Subject: INTERFERENCE BETWEEN TRUNK, REAR COMBINATION LAMPS AND/OR REAR BUMPER	Bulletin No: 09-028/04
	Last Issued: 8/26/2004

This bulletin supersedes last issued 7/21/2004. The WARRANTY INFORMATION has been modified.

2004 RX8 - VINs lower than JM1FE17**40113721

CHECK FOR INTERFERENCE AT THESE POINTS - "A"

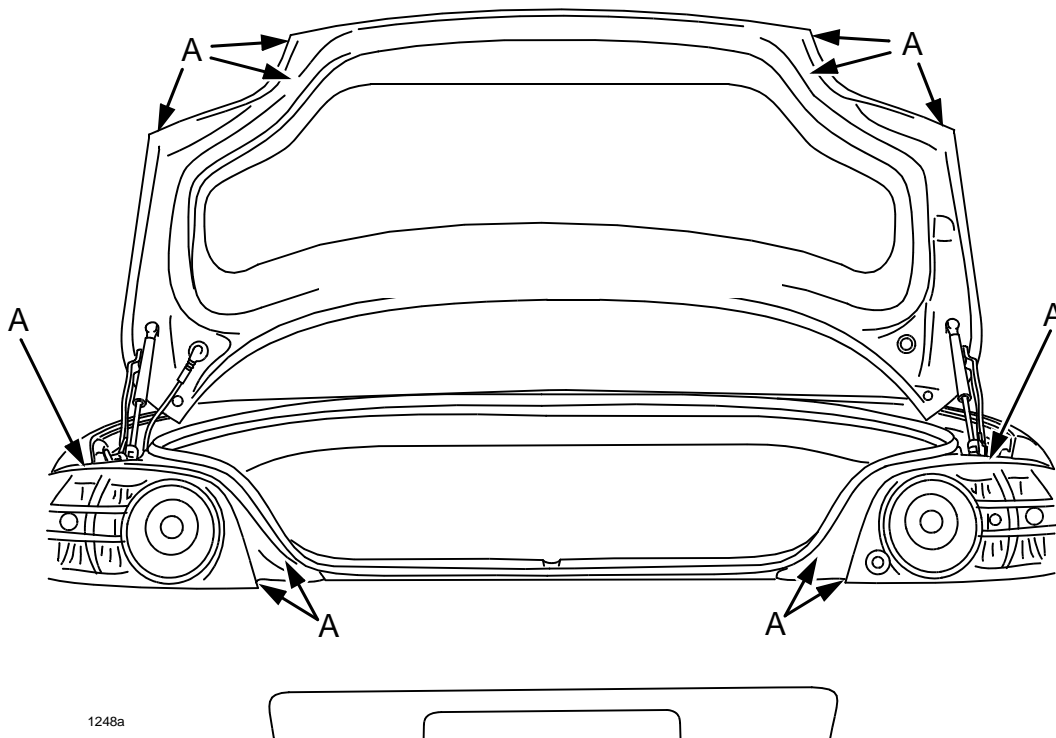
Some vehicles may exhibit damage on the left and right rear combination lights, trunk and/or rear bumper. This may be caused by interference between the trunk, rear combination lights and bumper.

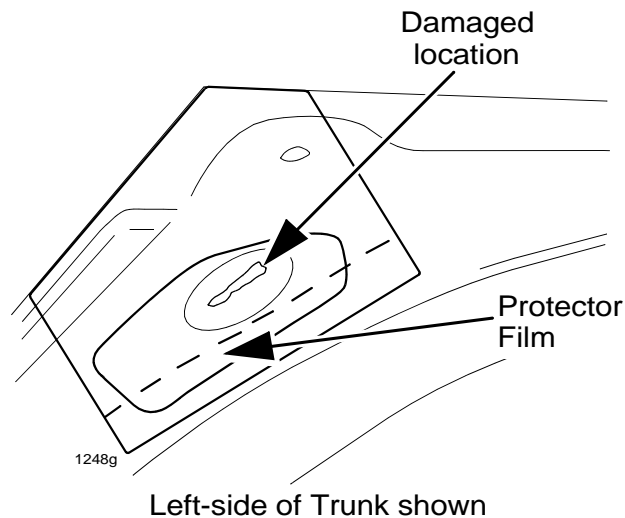
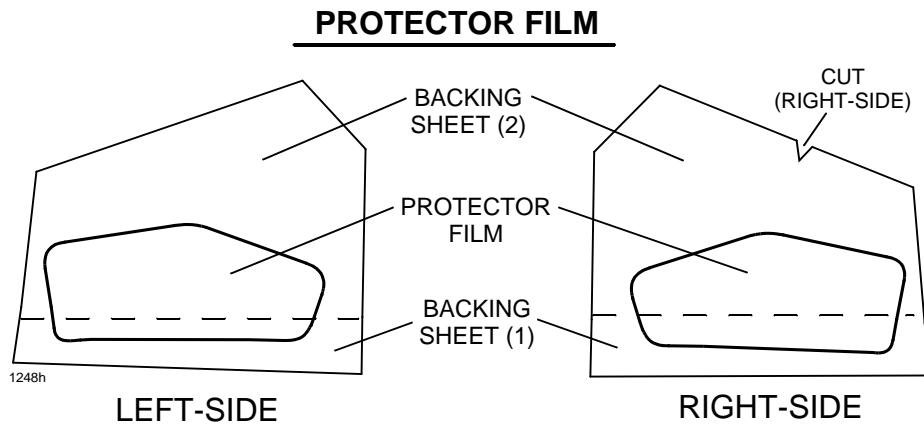
1. Verify customer concern. Check for damage caused by contact between trunk lid, rear combination lights, edge of trunk lid and/or rear bumper cover.
2. Repair contact damage as follows:
 - a. Use de-greaser or window cleaner to clean the damaged area.
 - b. Polish the damaged area and around the damaged area with a light buffing compound safe for clear coat.
 - c. Remove all compound residue using a soft cloth.
3. Apply protector film to the trunk lid inner panel as follows:
 - a. Use de-greaser to clean the area where protector film will be applied.
 - b. Place the protector film (without peeling off the backing sheet) by the edge of trunk lid as shown.
 - c. Peel off the lower portion of the backing sheet (1) and attach the protector film.
 - d. Peel off the remaining portion of the backing sheet (2) and attach the protector film.

NOTE: Do not allow the edges of the protector film to curl.

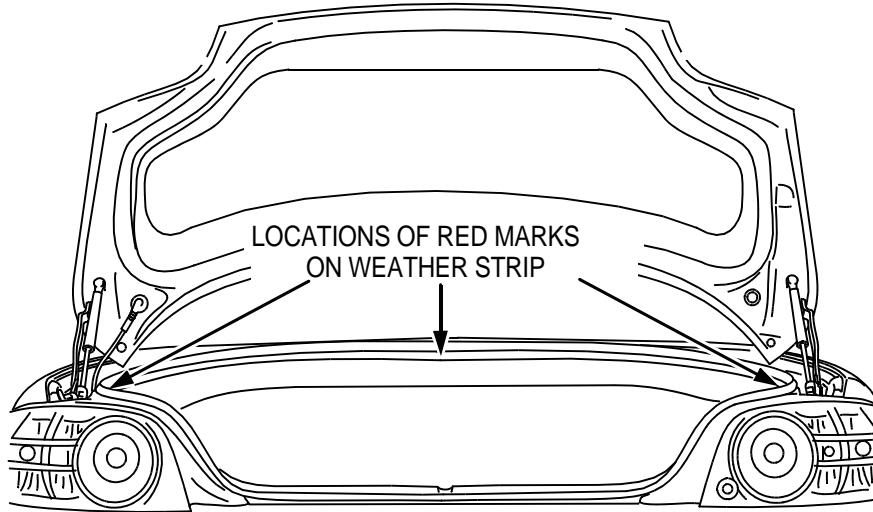
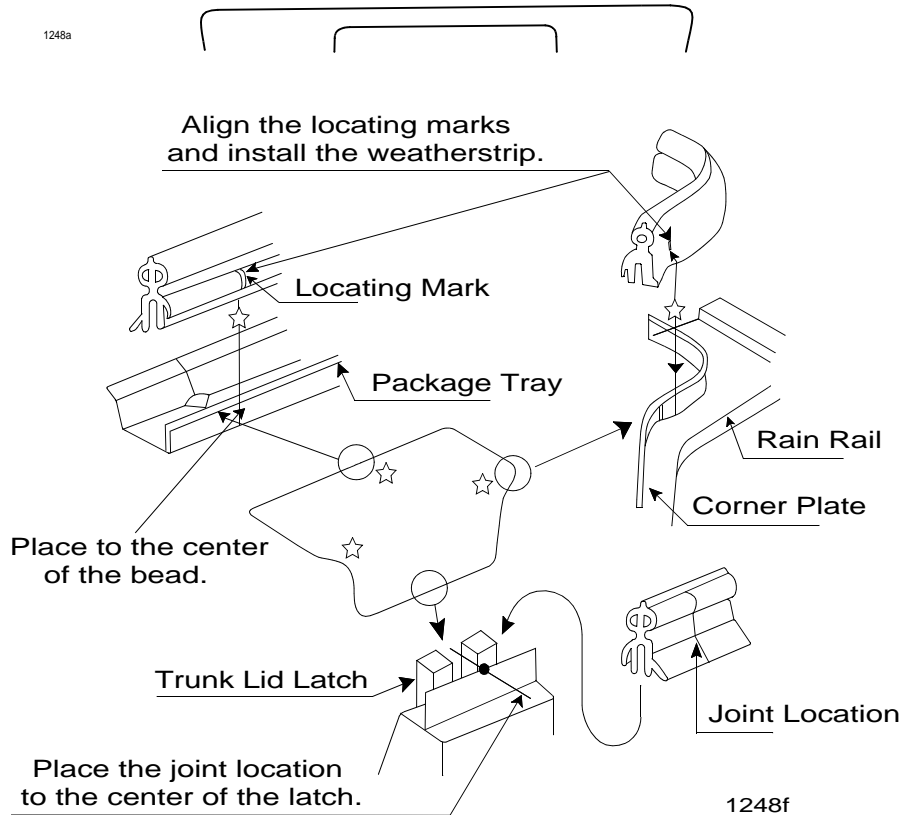
4. Replace the trunk weather-strip with a modified one.
 - a. Note position of red marks on old trunk weather-strip prior to removal. One will be at each rear corner of trunk opening and one will be in center of trunk, near rear window. These marks will aid in installation of modified trunk weather-strip.
 - b. Install modified truck weather-strip.

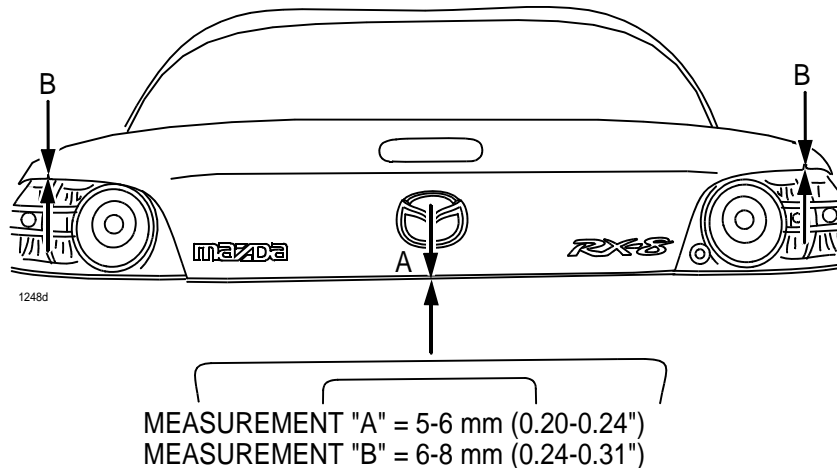
5. Measure distance between trunk lid-to-rear combination light and trunk lid-to-rear bumper. If measurements are as follow, go to STEP 7. If measurements are not as follow, go to next step.

- Measurement **A** between the trunk lid and bumper:
5.0 - 6.0 mm (0.20 - 0.24 inch)
- Measurement **B** between the trunk lid corners and rear combination lights:
6.0 - 8.0 mm (0.24 - 0.31 inch)
